Proposed changes to the England Coast Path at Canal Road, Strood, Medway, Kent

Natural England's Variation Report to the Secretary of State

Coastal Access Variation Report IGR VR15
May 2022

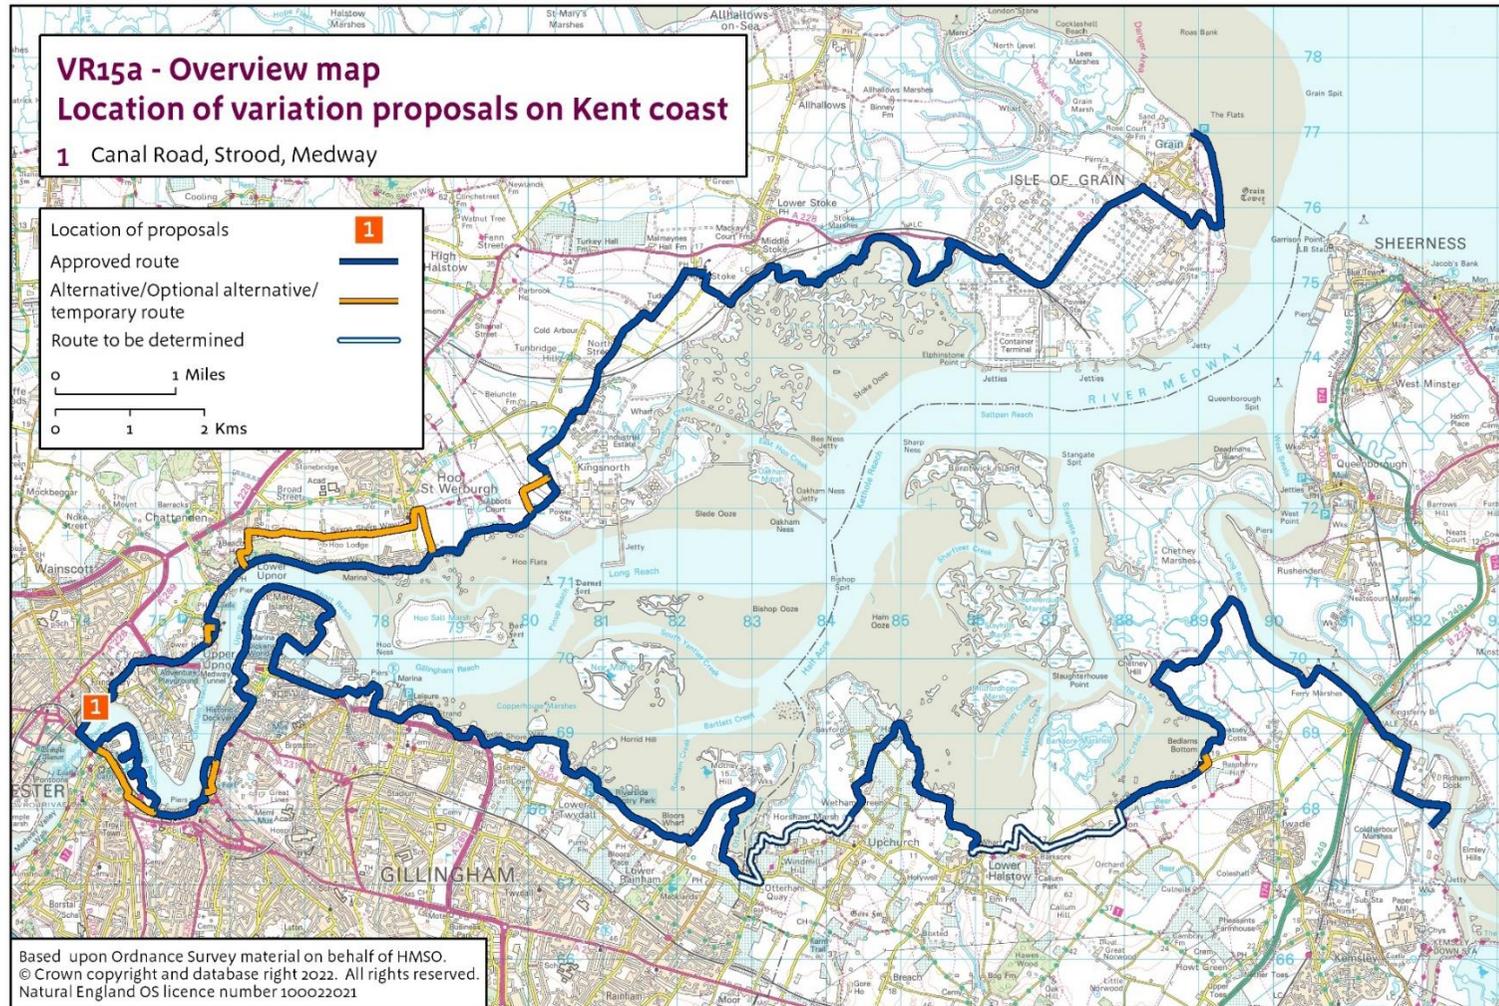
2.1.1 Since our original proposals were approved, land in the Canal Road area of Strood, Medway has been cleared, raised and prepared for future housing development (known as the 'Strood Riverside'). This included the provision of a new flood defence barrier which has been constructed over the approved alignment. In addition, the alignment of Canal Road has changed where it previously supported the approved trail. The trail is therefore required to change to reflect these developments.

2.1.3 Due to the placement of the new flood barrier and the recently realigned section of Canal Road, the varied route would be located upon the pavement along Canal Road at the southern end of Watermill Gardens. It would then follow the pavement on the east side of the realigned Canal Road to Riverside Road. Due to the location of the flood barrier, Watermill Gardens will not be used for the trail, however it will be part of the coastal margin.

Map IGR-VR15b Key Statutory Environmental Designations - shows the extent of these designated sites in relation to the proposal.

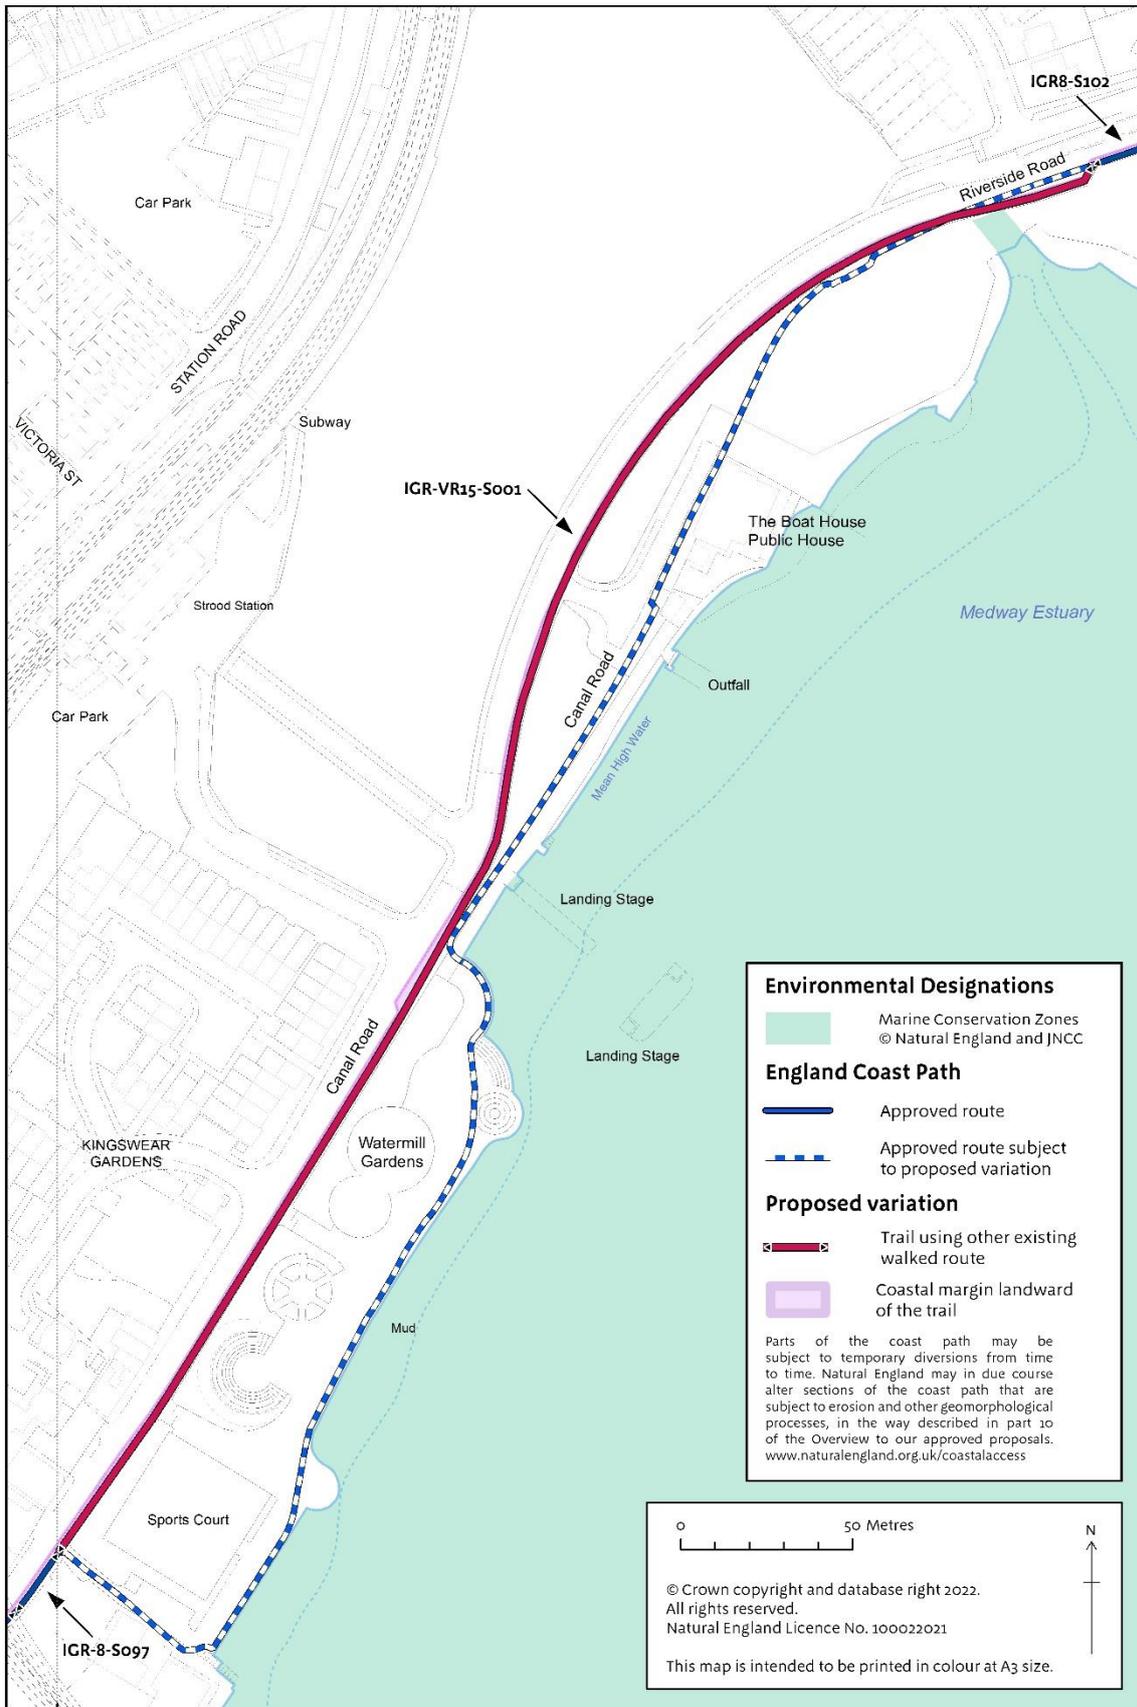
2.2.5 The proposed alignment follows Canal Road which is located to the landward side of the approved route. Canal Road is located outside of the designated site and further from sensitive intertidal habitats than the approved route. In addition, the intertidal mud in this area is unsuitable for public access and as part of the approved report it is subject to an all-year exclusion. As such, walkers are unlikely to access the intertidal and no special measures are needed in respect of our proposals.
